Customer Letter
(Internal Reference: TSB PR92820)

Quality Improvement Action

- 1) Dräger Plus / PSS Series Lung Demand Valves (LDV)**
Manufactured date range: September 2017 through March 2018

Score Marked (Error) Spring

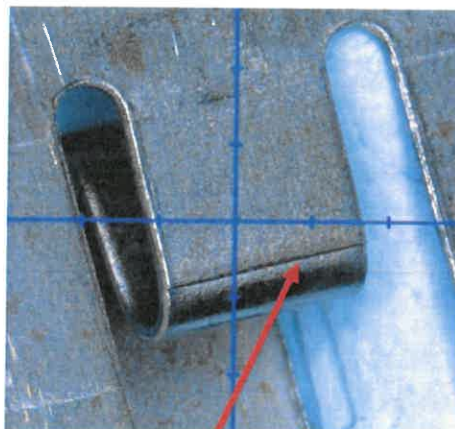
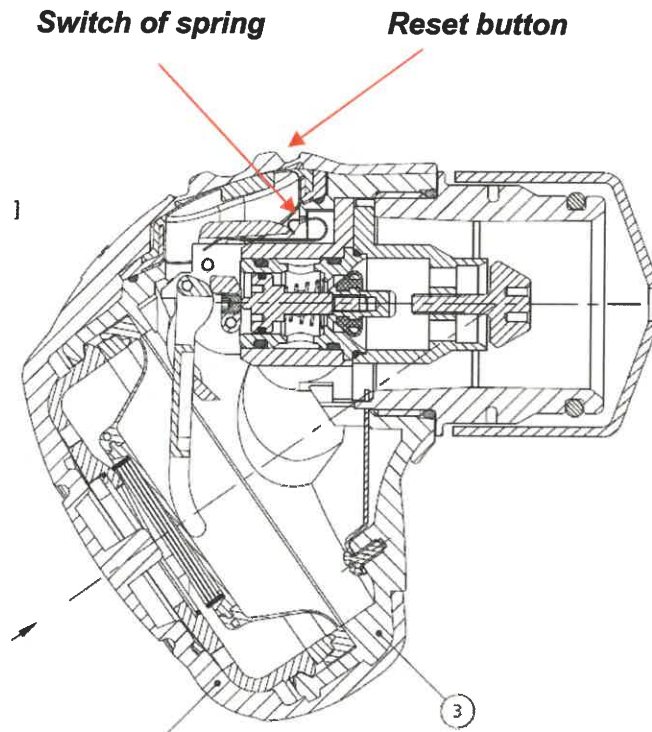
The manufacturing error has produced a score mark on the switch-off spring. The photos below show a normal un-marked spring, and a spring with the manufacturing error score mark. The LDV section view shows the position of the switch-off spring when fitted to the LDV.

Extensive testing of the manufacturing error marked springs have shown that the score mark will eventually reduce the design specified fatigue resistance of the spring. However, the score mark error will not affect the safe function of the LDV during use. The section below will explain the effects of the error. The expected service life of the product with the manufacturing error is estimated to be at least 4 to 7 years assuming normal and typical use.

The switch-off spring is not available as a spare part therefore the repair will require the replacement of the Air Transfer Block (ATB) in the LDV, as well as the corresponding clamp and clip. After replacing the ATB a full LDV function test will be required
